City of Placerville

ADDENDUM NUMBER 3
Dated: November 18th, 2019

UPPER BROADWAY BIKE LANES PROJECT
(INCLUDING UPPER BROADWAY PEDESTRIAN CONNECTION)
PROJECT NO. CML – 5015 (027 & 029)
CIP # 41508
and
UPPER BROADWAY STORM DRAIN REPLACEMENT PROJECT
CIP # 42004

TYPICAL SECTION

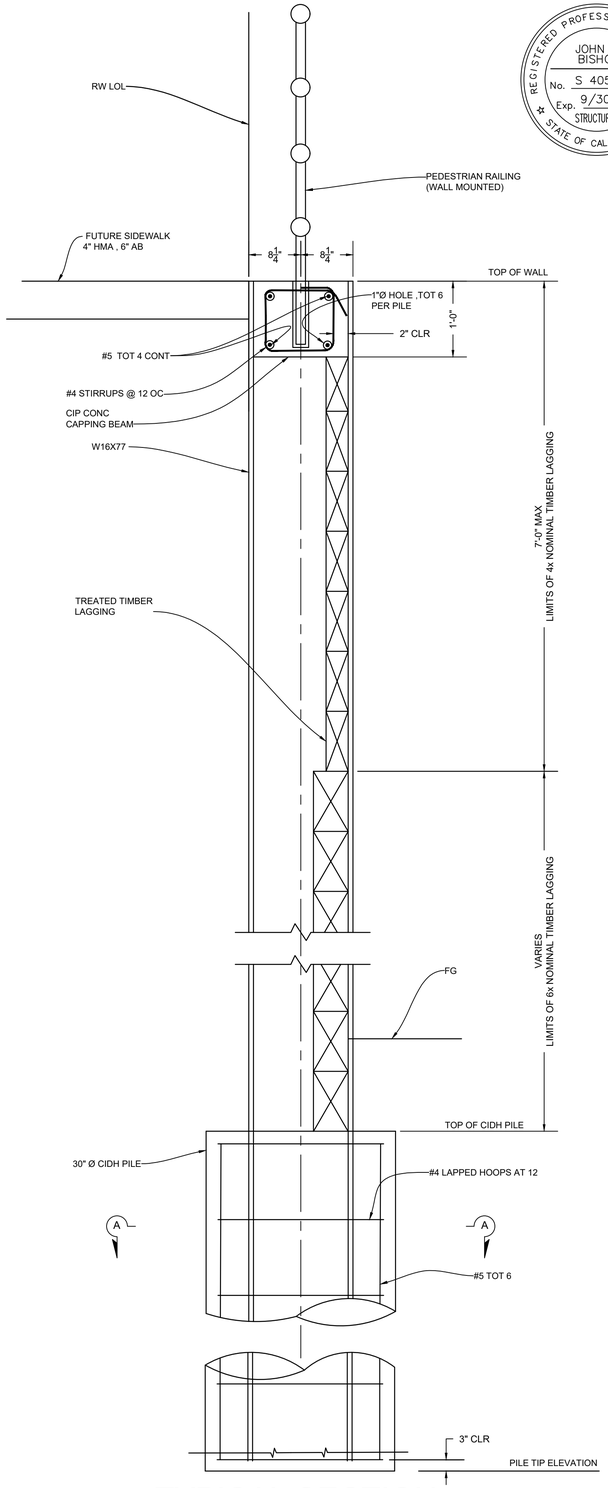
- Revised spiral reinforcement of CIDH piles in the typical section and Section A-A.
- Added dimensions to the gap closures in the part plan at box culvert view.
- Added stud and call out to the piles in the part plan at box culvert view to show how the capping beam gets connected to the piles.
